Application for Licence Amendment

Licence Number	L9336/2022/1
Licence Holder	Hastings Technology Metals Ltd
ACN	122 911 399
File Number	DER2022/000260
	Legal description – G09/14, M09/158, M09/157, G09/18, G09/17, G09/20, G09/26, L09/69, L09/93, L09/95, M09/161, M09/162, M09/176 and M09/178 WEST LYONS RIVER WA 6705 As defined by the coordinates in Schedule 1 of the Revised Licence
Date of Report	17 May 2024
Decision	Revised licence granted

Figure 1: Distance to sensitive receptors

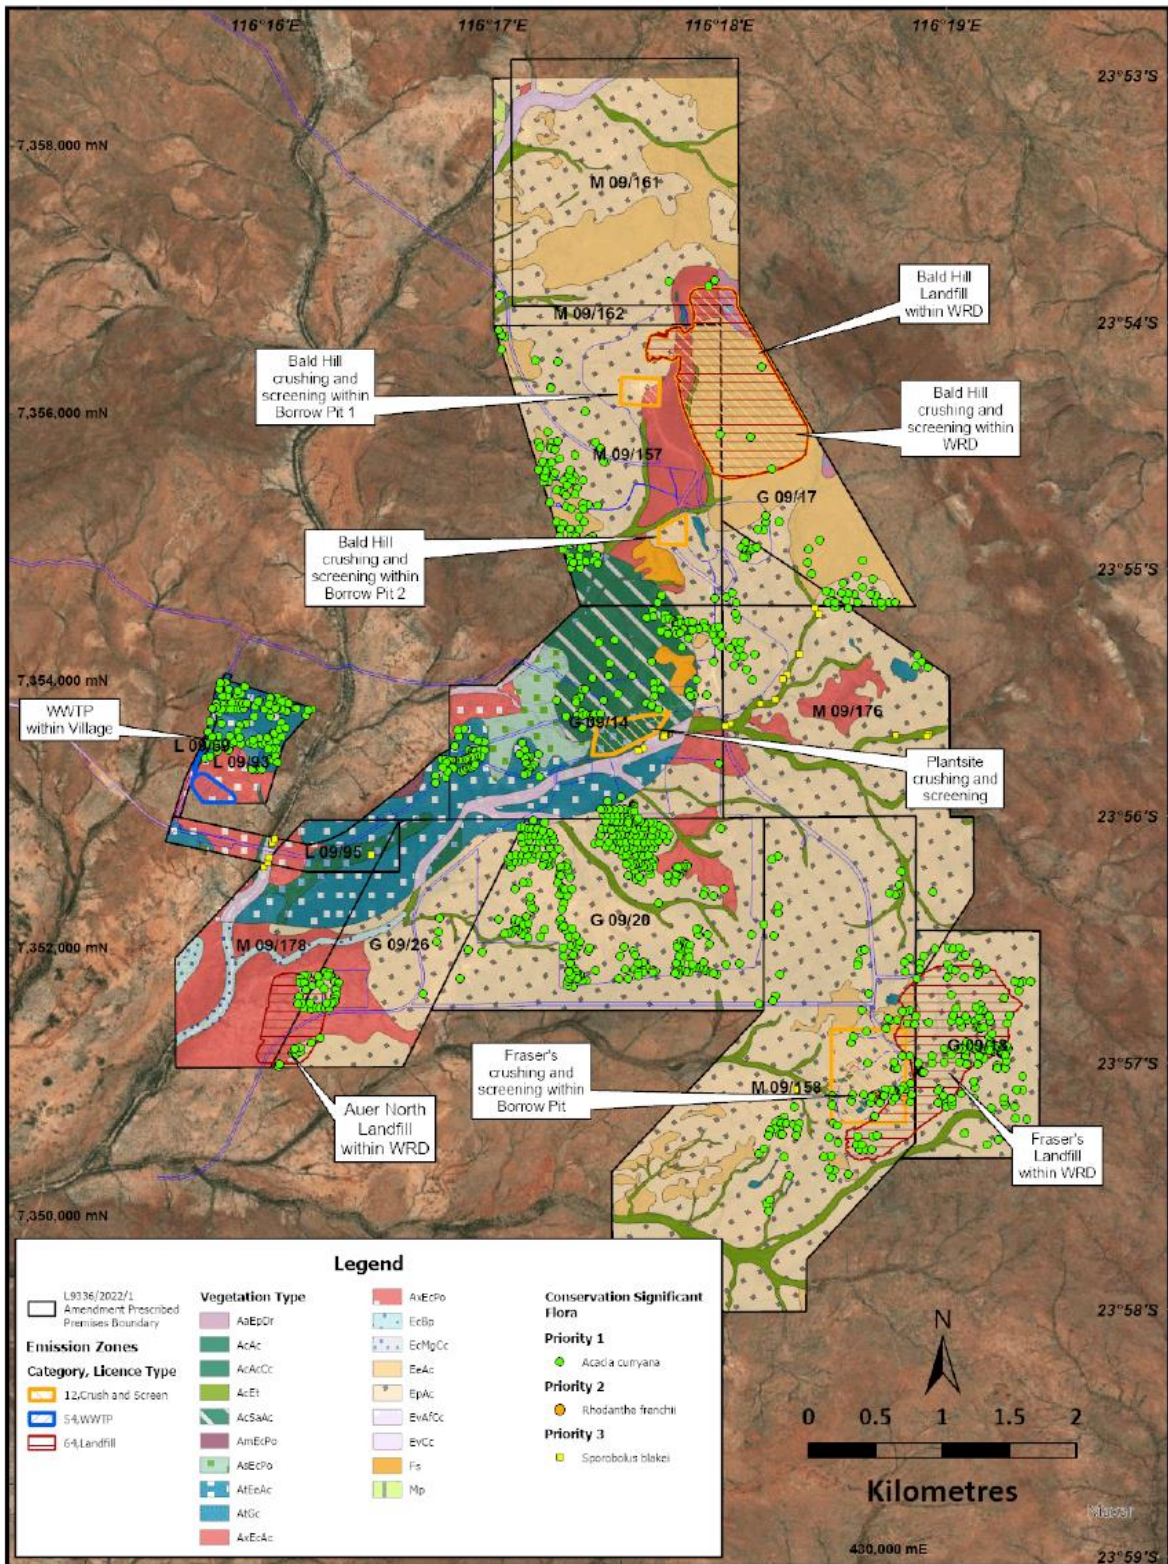
Condition	Summary of Licence Holder's comment	Department's response
Section 3.1.2, Table 6 – superficial water, Page 15	Mobile crushing and screening activities will not be located within 50 m (100 m buffer) of watercourses. Location 2 – 50 m Location 5 – 50 m	Updated as requested.
Figure 1: Distance to sensitive receptors, Page 16	Updated map to show 100 m buffer within crushing and screening emission areas.	Updated as requested.
